SAFETY EVALUATION REPORT

VERMONT YANKEE PLANT

VERRIDE OF CONTAINMENT PURGE ISOLATION AND OTHER ENGINEERED SAFETY FEATURES ACTUATION SIGNALS

Figure 1. PCIS Control Scheme

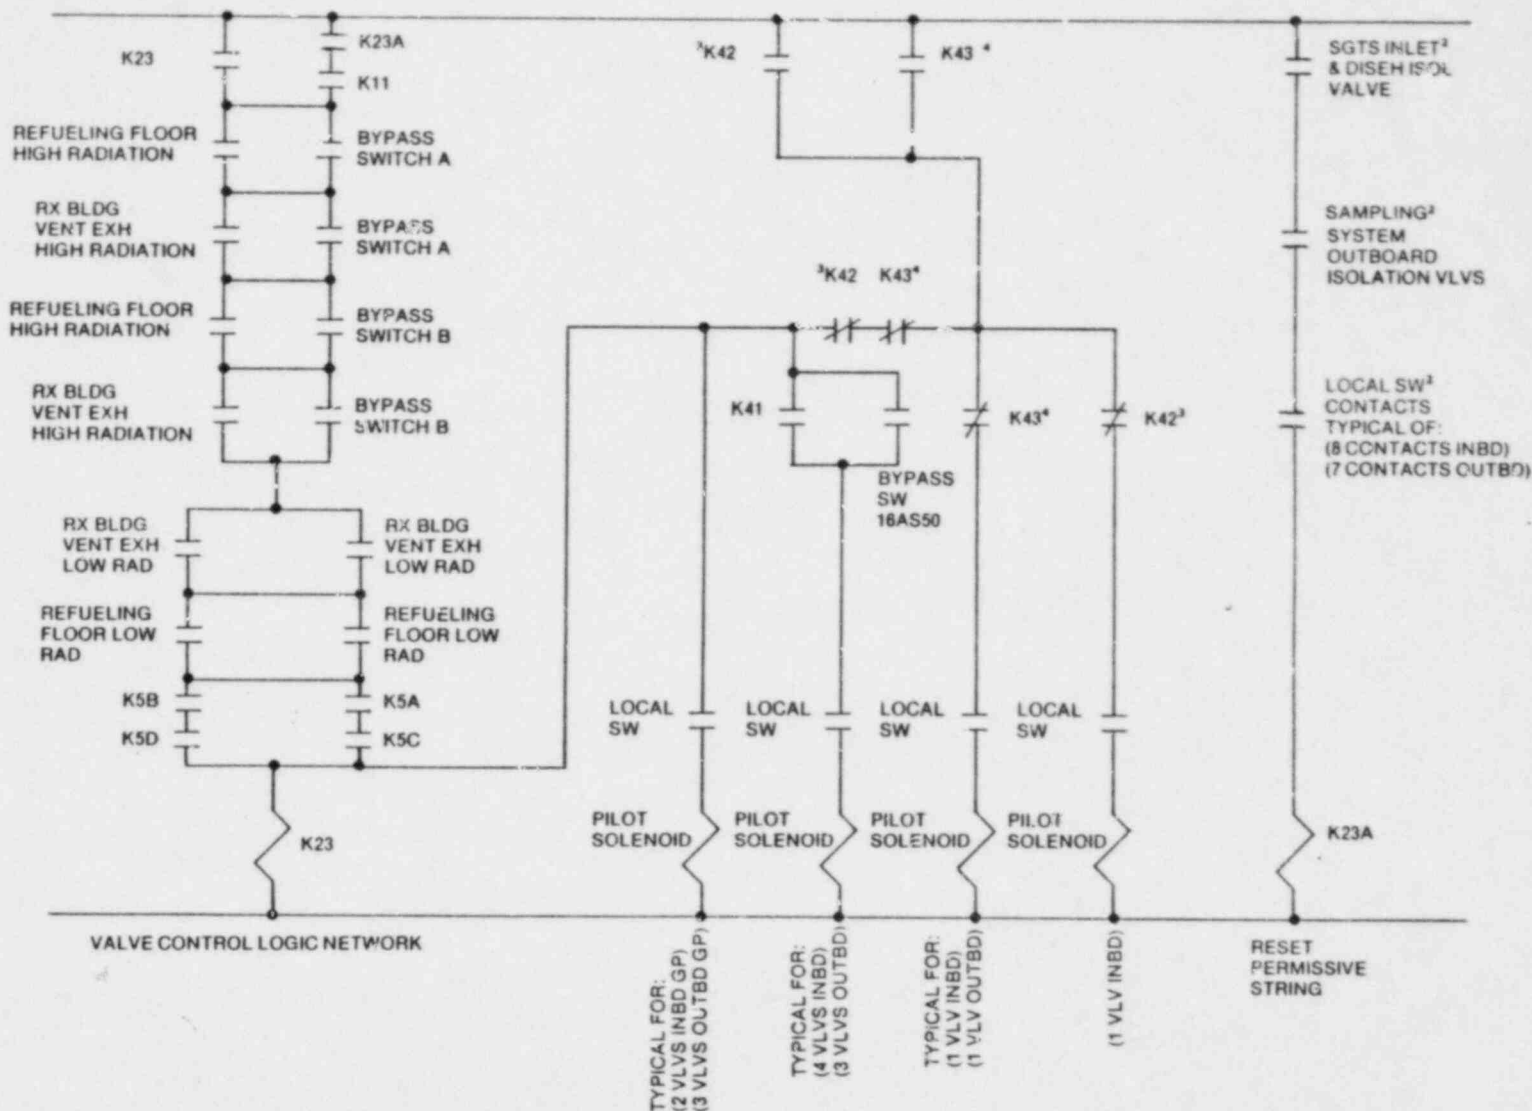
Either reactor building ventilation exhaust or refueling floor zone high radiation isolation signals can be bypassed by switches (Figure 1), one for each electrical train, which close contacts paralleling the appropriate logic network parameter isolation contacts. Activating any of these bypass switches

is indicated by a single red light for each of the electrical trains. Since the contacts providing this bypass feature are incorporated in the trip logic network, the actuation of these switches cannot in itself restore power to the pilot solenoids. Restoration of power to the valve solenoids, allowing valve operation, is accomplished by the use of the bypass switch followed by the system reset as previously described.

Each override switch provides one contact which energizes a red light in the control room to display the bypass condition to the operator for each individual trip parameter when the switch is placed in the override position. However, no audible alarm is provided, and consequently Criterion 3 is not satisfied.

It is concluded that the PCIS circuit design satisfies the NRC staff criteria for containment ventilation and purging operation with the exception of Criteria 3 and 4. Satisfaction of Criterion 3 will require the installation of an audible alarm associated with the bypass switches for reactor building ventilation exhaust and refueling floor zone high radiation. Satisfaction of Criterion 4 will require that a radiation detector which monitors containment (i.e., drywell or torus) activity be provided and used to automatically initiate primary containment isolation.

Figure 2. RHR Control Scheme

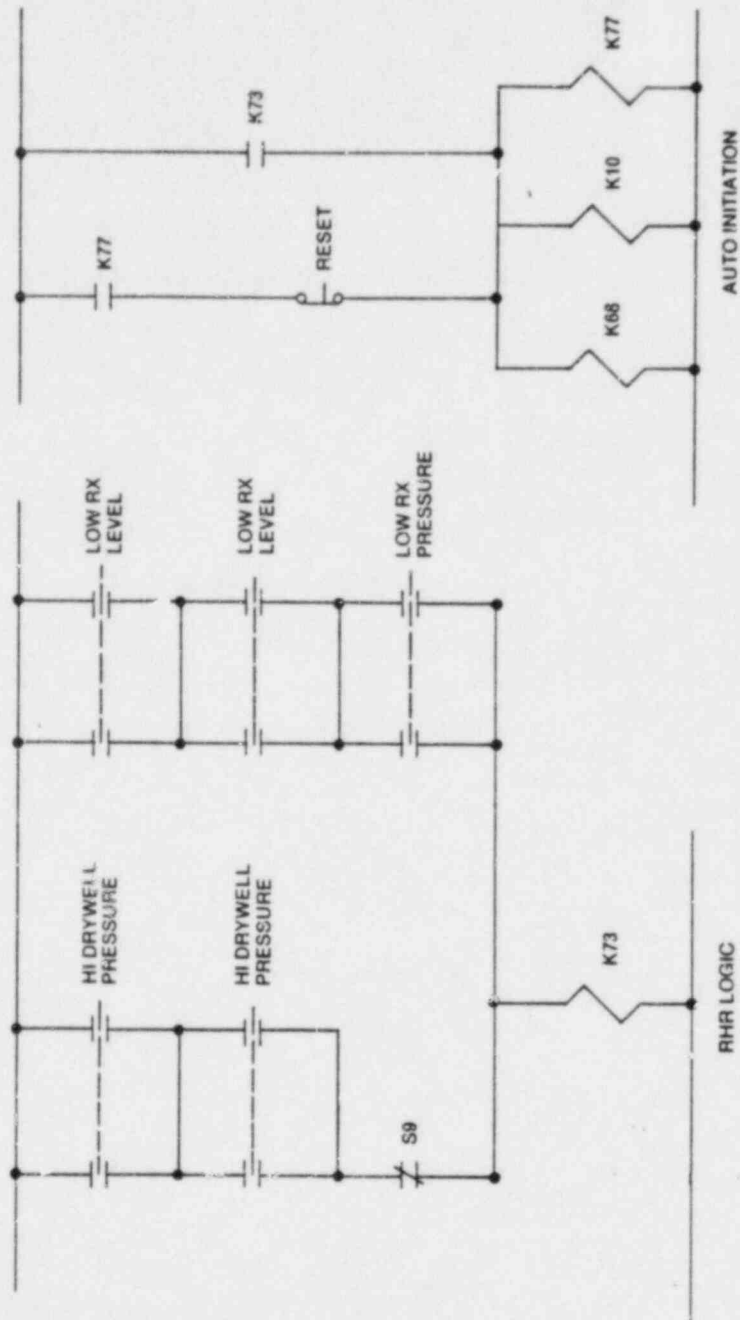
The RHR logic circuit is activated when an isolation signal is received, thus energizing slave relay K73 (Figure 2). The K73 contacts in the auto initiation circuit are then closed, causing the seal-in (K77) relay and contacts to pick up. Switch S9 in the RHR logic circuit is provided to allow testing of the high drywell pressure signal; it is a keylocked, two-position (Auto-Test) switch.

Figure 3. Containment Spray Valve Control Circuit

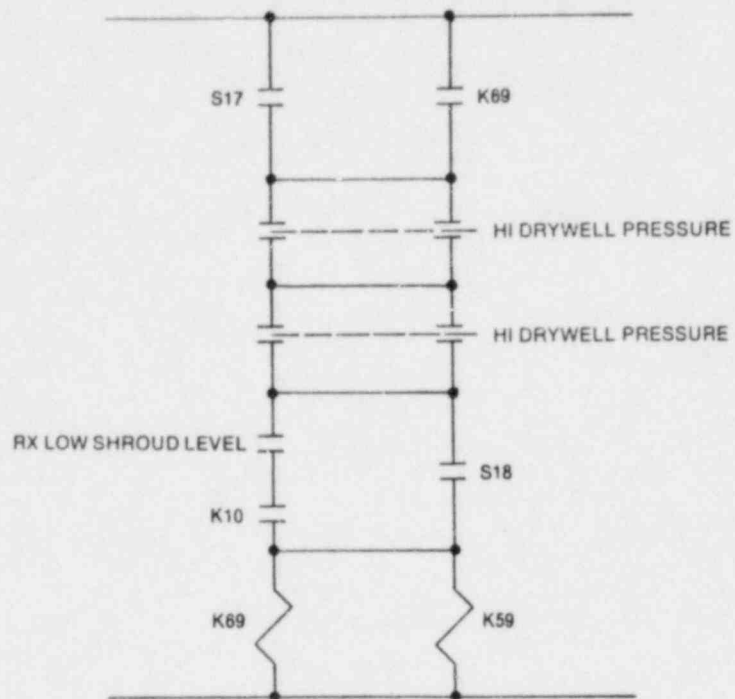
No instances were found in which the overriding of one type of safety actuation signal caused the blockage of any other type of safety actuation signal for those valves that serve containment isolation function only. However, ten ESF actuated valves (MO-39 A & B, MO-31 A & B, MO-26 A & B, MO-34 A & B, and MO-38 A & B), which have functions in addition to containment

isolation, are provided with control circuitry that allows the bypassing of automatic ESF actuation (Figure 3). However, operation of these valves may be required to provide containment spray for pressure control of the containment atmosphere in an accident environment. //

It should be noted that manual initiation of containment spray with an isolation signal present requires (1) activation of the containment spray valve control circuit (positioning of S17, high drywell pressure signal present, and positioning of S18 [Rx low shroud level emergency override] or K1G [RHR auto initiation activated] and reactor water level above the shroud - Figure 3), (2) manual operation of a control switch (access restricted) in each individual valve control circuit, and (3) a containment high pressure signal. In addition, system-level annunciation of this condition is provided. Consequently, Criteria 2 and 3 are satisfied for these ten valves.

The RHR circuit design at Vermont Yankee satisfies the NRC staff criteria with the exception of Criterion 1 for ten valves associated with the containment spray function of the RHR system. This matter is identified for NRC staff consideration.
